B787 Program update - F205

Stuart Tucker Product Support & Technical Services Manager
Billy Walker Technical Support Team Leader
Aftermarket FMC

Fuel Valve Actuator PN 53-0037 to 53-0049

Issue/Application

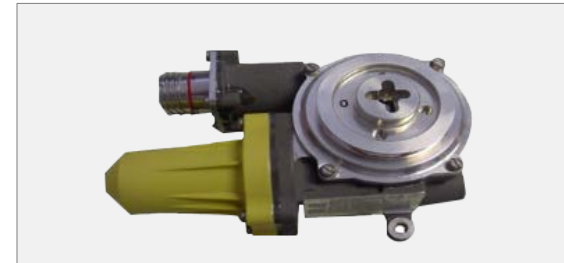
- **Platform:**
 - Boeing 787-8
- **Aircraft problem/impact:**
 - To meet compliance with 25.901(c)
- **Description of problem**
 - Original design, without diodes, only the destination position is signalled and to address in-service failures
- **Identify assembly/part number:**
 - Fuel Valve Actuator PN 53-0037 to -0049
- **Consequence(s)**
 - Modification of 6 locations on Aircraft
